# iEi Products Change Notice

**Status: Running Change**

IEI is initiating a conversion for AFL2-W19A(B)-H61 Series where products will undergo the following changes, and please find attachment A for detailed revision models.

## System Changes:

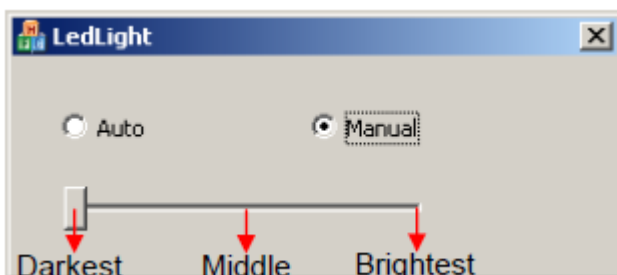
1. **Function key is changed from mechanical key to membrane keypad for product reliability enhancement**

2. **Luminance of function indicator and IEI Logo indicator can be configured by 3 luminance level (Darkest, middle, and brightest) and auto control by environmental brightness .**

**And IEI will provide AP program to help you to manage the luminance of indicators!**
